Caesar Apparels Ltd-New

18th December 2016

Observations

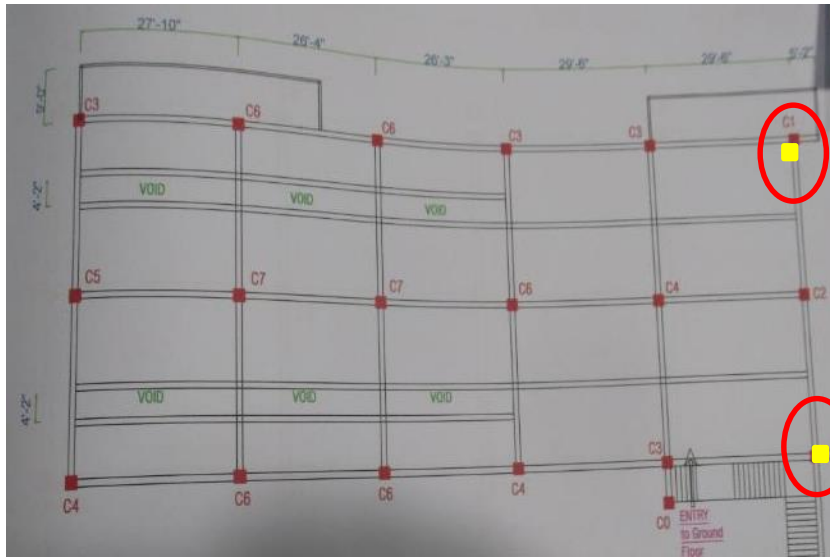
Inconsistency between Structural Drawing and As – Built Condition

COLUMN INDEX	COLUMN DIMENSIONS	
	UP TO G.B.L.	G.B.L. TO 2ND. FLOOR
C1 (24"x24")	 27" Main bars: 16 - Ø16 mm	 24" Main bars: 16 - Ø16 mm

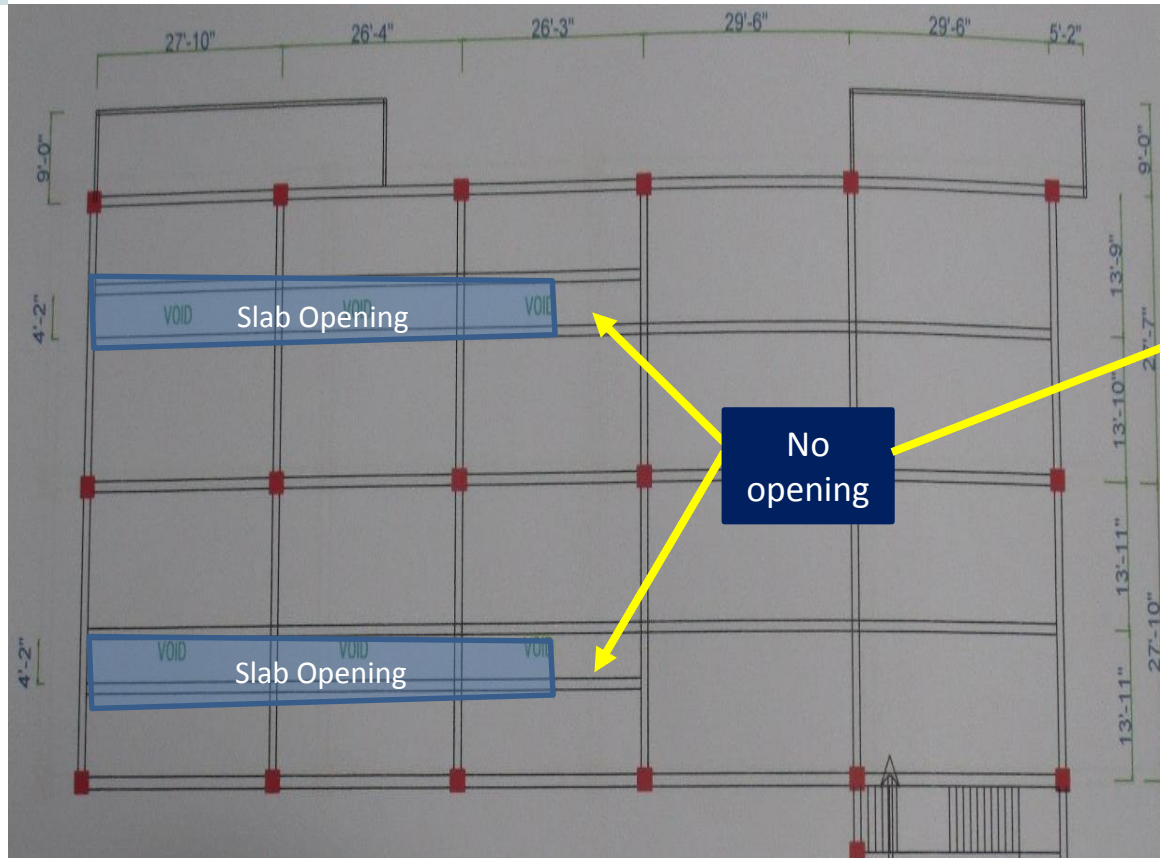
During inspection, The highlighted columns(C1) were found under-sized compared to As- Built drawing. In drawings the size of the column is mentioned (24inX24in), but we found (23inX15in)

Long Face(C1 column)(23 inch)

Short Face (C1 column)(15 inch)

Bamboo ladder was observed to go upstairs

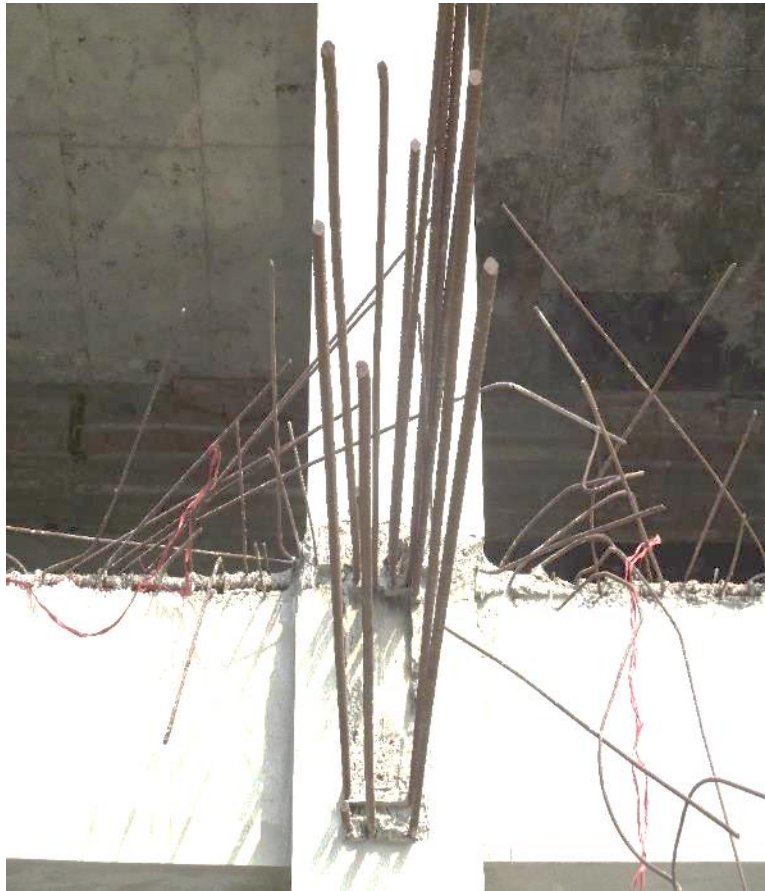
During inspection, Bamboo ladder was observed to go upstairs. Although, upper floors were found unoccupied during inspection. Factory Engineer is required to ensure that properly constructed stair is installed before they are being used.
